# TECHNICAL INFORMATION

Range <b>H&amp;C – Ho.Re.Ca.</b>	Model <b>9100 – KARISMA – CANTO TOUCH</b>	N° T.I. <b>05_2017</b>	
Serial Number <b>See page 1</b>	Subject <b>Modification of 250VA SWITCHING POWER BOARD</b>	ISSUED FOR (X)	Action Information <b>X</b>

**New**  
**250VA switching power board**  
Spare part code: **261184**

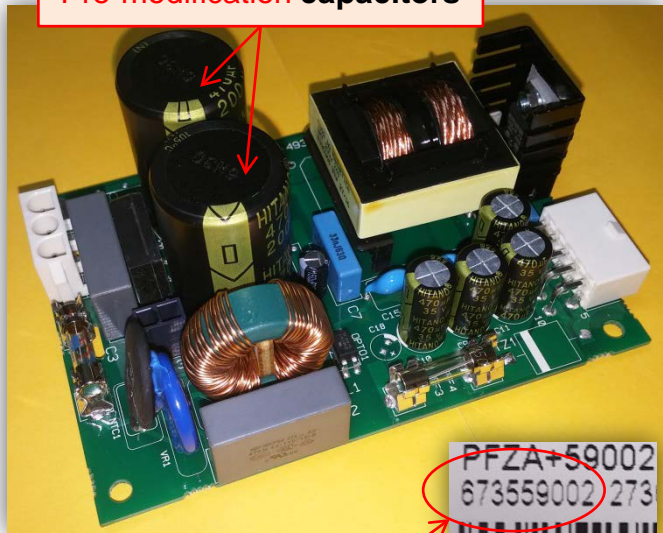
Be informed that with the aim to improve our equipment, the **250 VA switching power board** has been modified.

The **two capacitors** have been modified.

**New capacitors**

**Pre-modification capacitors**

The *new power board* can be installed in the machines prior to the S/N mentioned in the page 1.
